FIELD SERVICE BULLETIN

FSB Number:	LVCCFSB2003-98 (Rev. A)
Author:	Tony Bryan
Date:	December 03, 2003
Total No. of Pages:	3
Subject:	Triplets PA Replacement – Eagle IC
Model Affected:	V300, V303, V400, V500, V525, V600
Level of Repair:	3/4

5189818N01 Skyworks Eagle IC

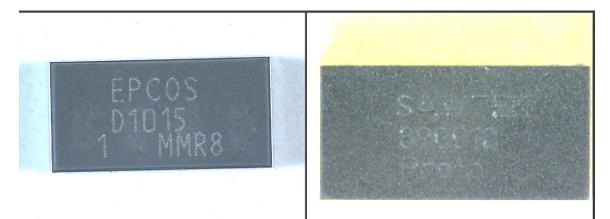
When replacing the U50 Eagle IC (PA) on Triplets products, use only parts from the same supplier. When replacing the FL100 FE Module, reference the chart above to ensure compatibility with the PA placed on the board. Use the images below to locate and identify the supplier of the Eagle IC placed.
